CITY OF TWO RIVERS, WISCONSIN

Neshotah Beach Bathhouse Renovation Project

**City of Two Rivers, Questions Received from ITB for Neshotah Beach Bathhouse
Renovation Project**

REMODEL FLOOR PLAN - CONCEPT "A"
1/8" = 1'-0"

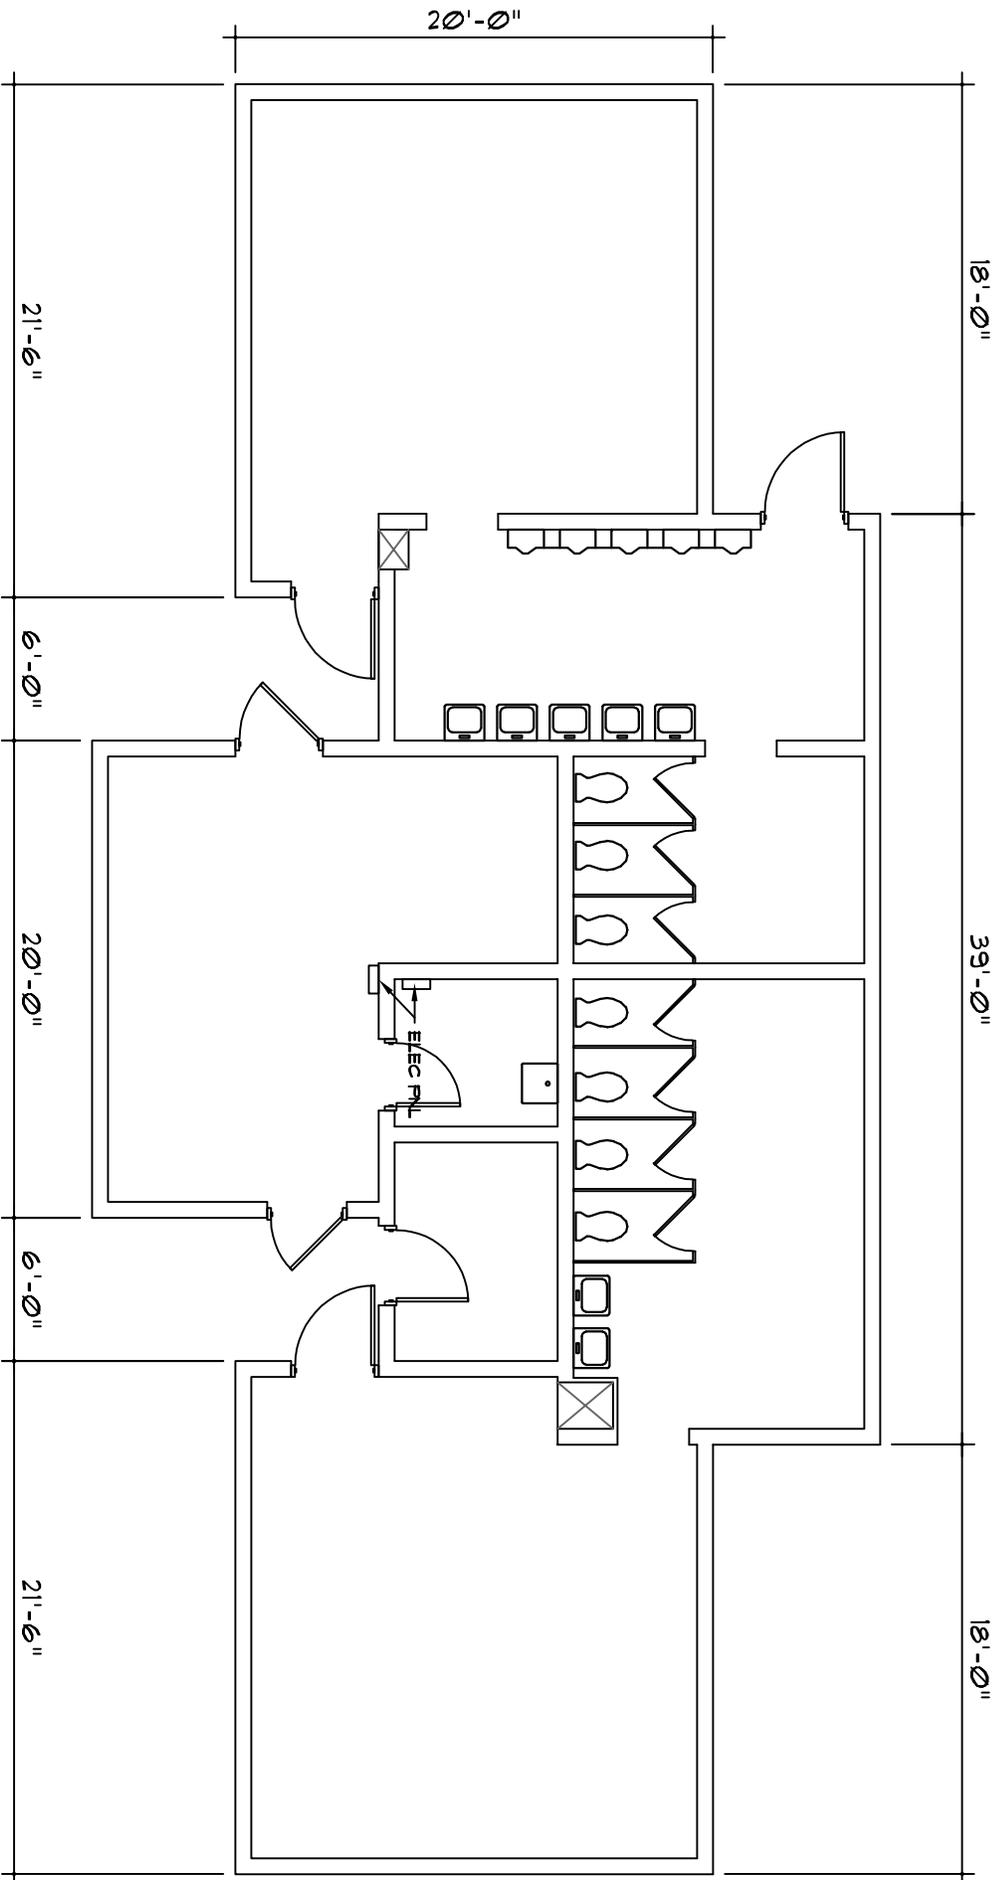
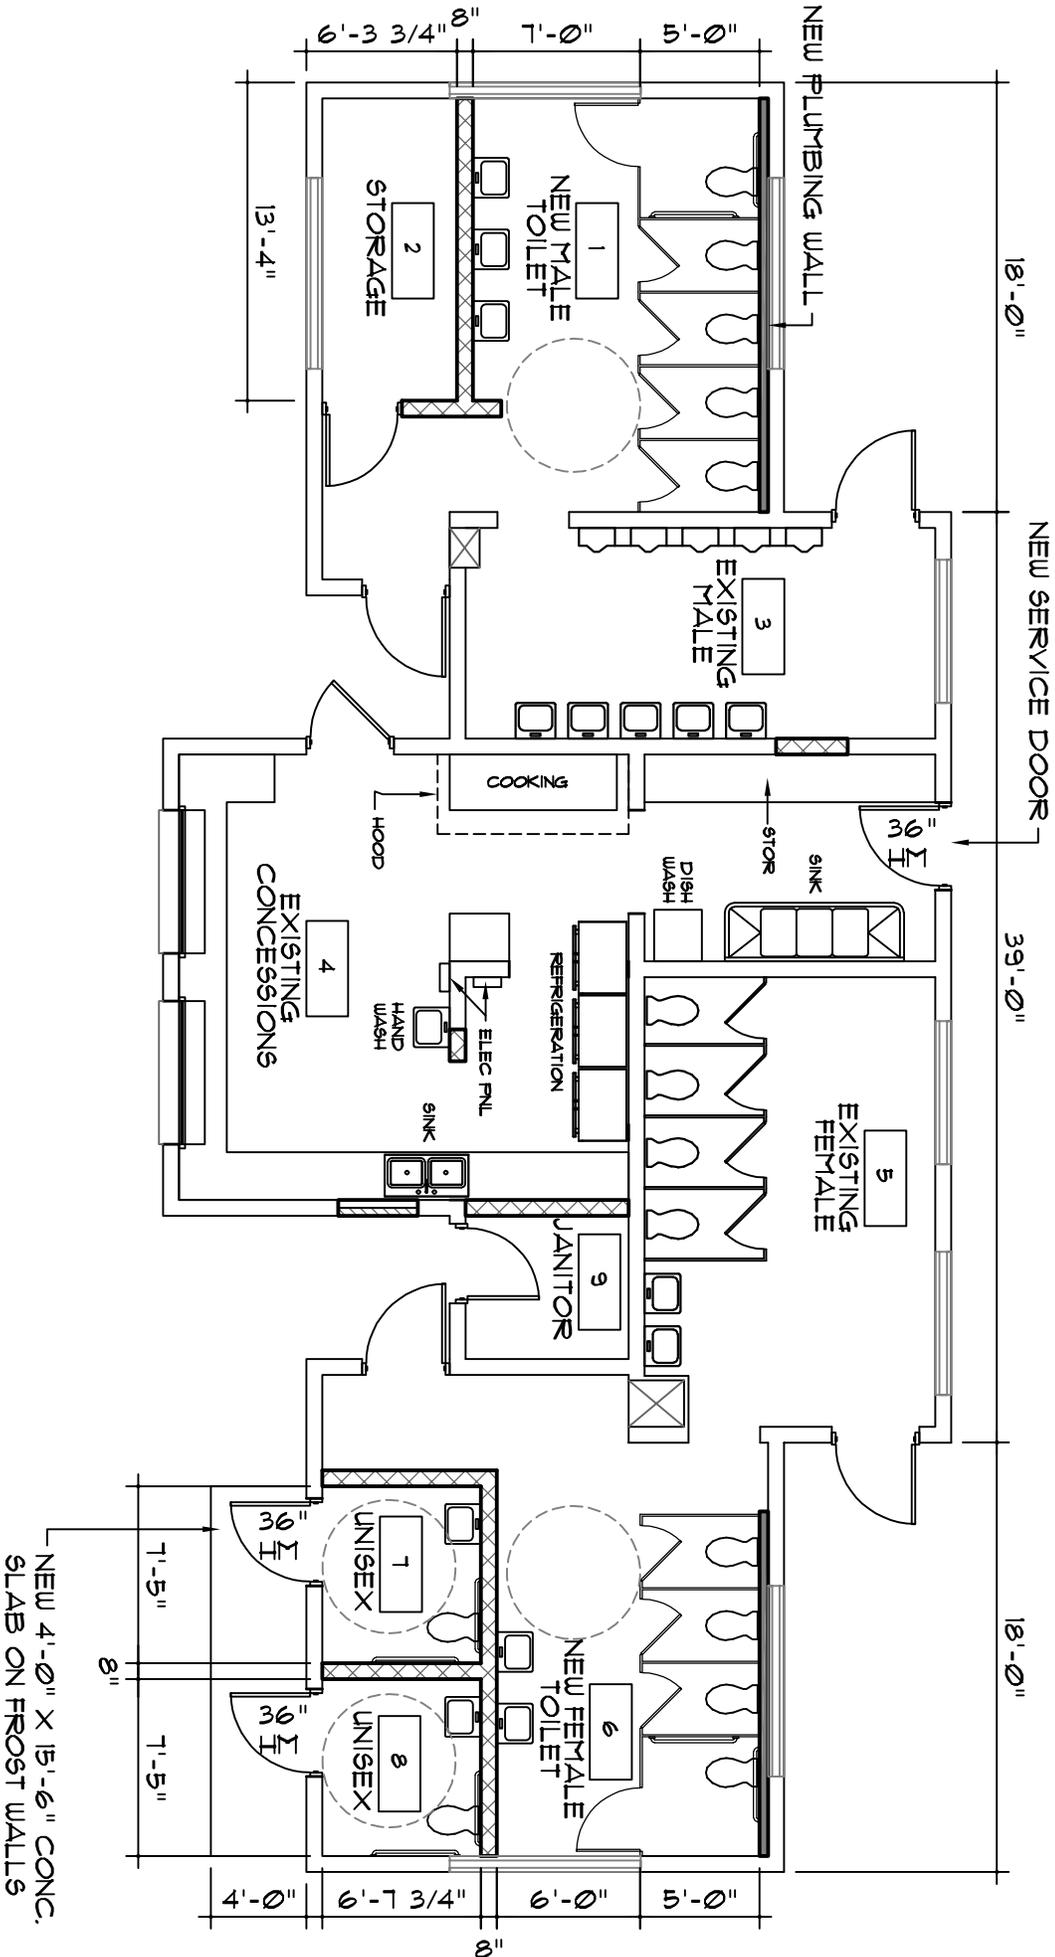
3. Are the front windows, exterior stainless-steel counter, and roll up doors on the front of the building within scope?

4. What aspects of the kitchen are within scope and not within scope?

5. Are the existing restroom fixtures and partitions staying in place?

6. Are the family style exterior access restrooms a part of the full restroom renovation and configuration estimate?

8. Are there any updates to the interior ceiling included in the proposed scope and budget?

9. Are there any updates to the flooring throughout the building within scope?

No, these features are not included in the proposed budget and scope.

Installation of new counter tops, cabinets, and sinks is within the proposed budget and scope. The City will directly purchase appliances. A cooking hood and range is not within scope.

The proposed scope and budget include keeping the current sinks, toilets, and partitions and only adding new fixtures for added capacity. However, providing an option for installing all new sinks and partitions is desired.

Yes, the two family style exterior access restrooms are a part of the proposed scope and budget. Providing a means for heating these spaces year-round is also included but is a low priority and may not be feasible due to the depth of the building's waterline.

Yes, within the kitchen. No, not within the restrooms.

Yes, all the floors in the restrooms and kitchen should have a new epoxy finish.
